STAFF REPORT

REGIONAL CENTER HEARING EXAMINER - HIGH IMPACT CASE

Case Number	2024-REG-016B
Address (approx.)	501 Indiana Avenue
Location	Center Township, Council District # 12
Petitioner	Indiana Avenue Partners, LLC., by Chris Mulloy
Zoning	CBD-2 (RC)
Request	Regional Center Approval to provide for: Construction of a 12-story mixed-use development, consisting of 263 dwelling units, 323 parking spaces within a parking garage, and approximately 35,475 square feet of amenity space, office space, and retail space.

Sub-Level 1: Canal Level

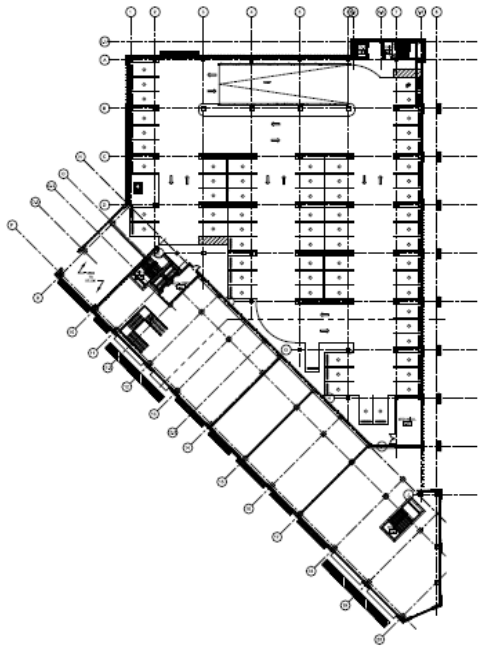
4. The canal level floor plan does not identify room labels, such as use for retail, amenity, etc. This level is adjacent to the Central Canal and a highly used pedestrian way. An amended canal level floor shall be submitted prior to the hearing. See SC 1.3.1, SC 1.3.2, SC 2.1.1, and SC 2.2.1.

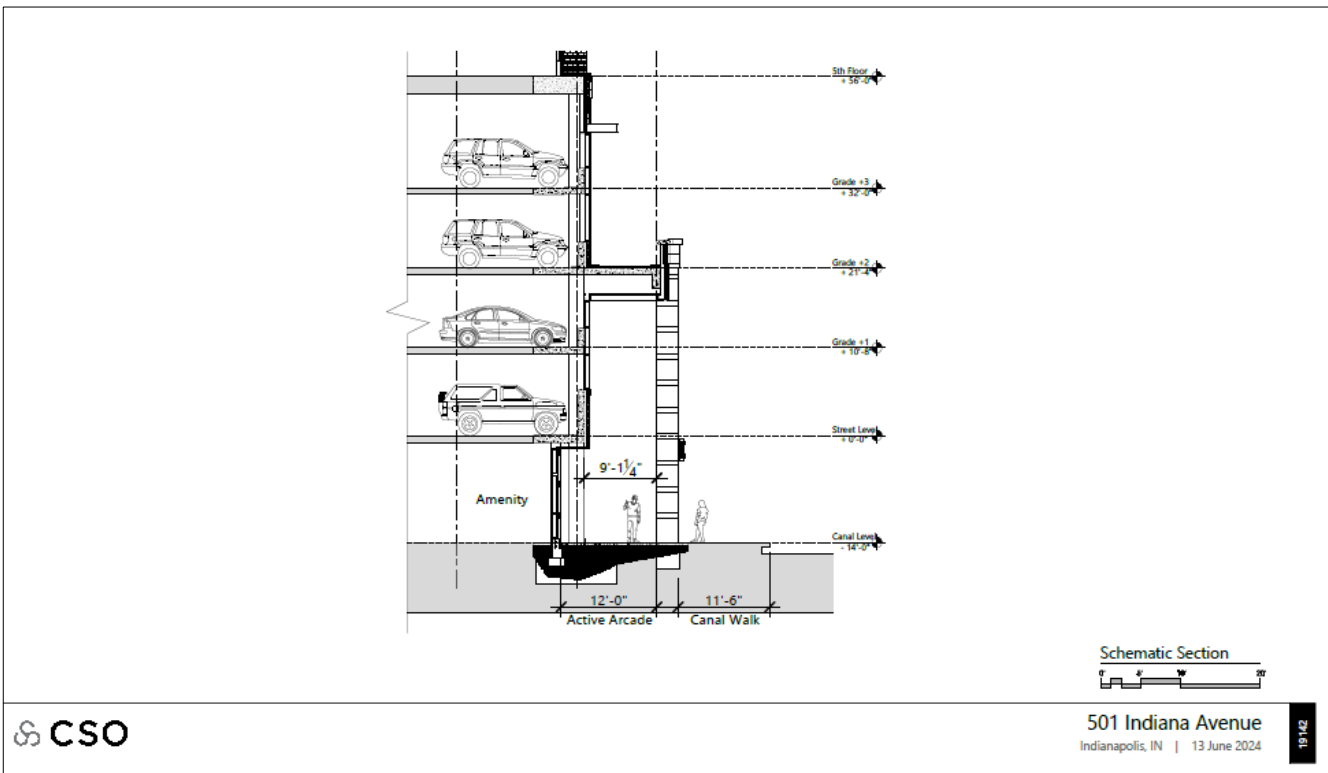
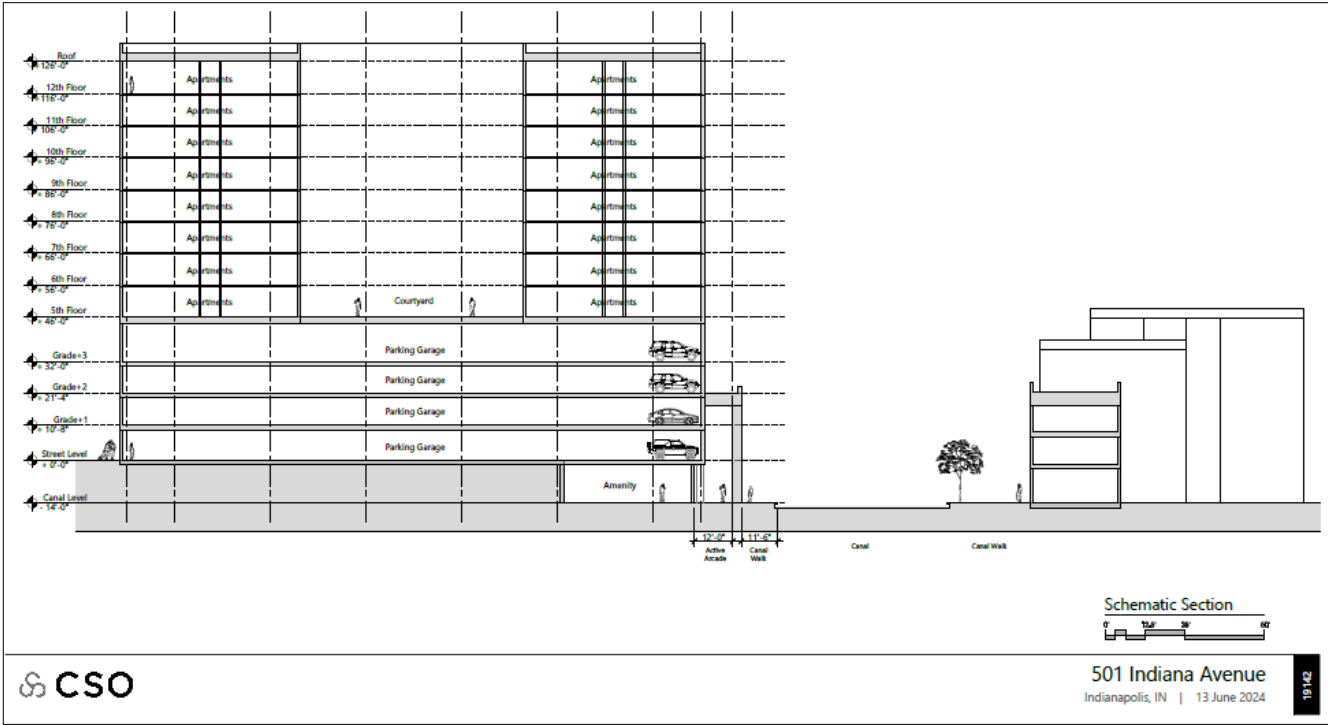
1. The east elevation includes material labels that are incorrectly identified. Specifically, the storefront windows at the parking garage are identified as Decorative Screen (L). The installation of storefront windows would be a consistent material in these areas, per SC 3.3.1, SC 3.3.3, SC 3.3.4, CA 1.2.1, CA 2.1.1, CA 2.1.2, CA 2.3.1, and CA 2.3.2. An amended east elevation shall be submitted and subject to staff review and approval, prior to the issuance of an Improvement Location Permit.

2. The east elevation indicates that there would be two different glass types on the upper and lower storefront openings. Glass shall not be highly reflective in any area of the building. Glass samples shall be submitted for review at the hearing. See CA 1.2.1, CA 2.1.1, CA 2.2.4, and CA 2.4.2. In addition, glass at grade level, adjacent to pedestrian ways, shall have a minimum 59% visible light and low reflectivity qualities. See CA 2.1.4 and CA 2.4.1.

3. The east elevation includes two areas where mechanical equipment would be shielded with the use of metal louvers, and the mechanical room also appears to be in a different location than shown on the plans. This must be clarified, prior to approval of this request. Additionally, staff is concerned with the use of a large new building material in place of storefront windows. See CA 1.2.1, CA 2.1.1, CA 2.1.2, CA 2.2.1, CA 2.3.1, CA 2.3.2, and CA 4.4.1.
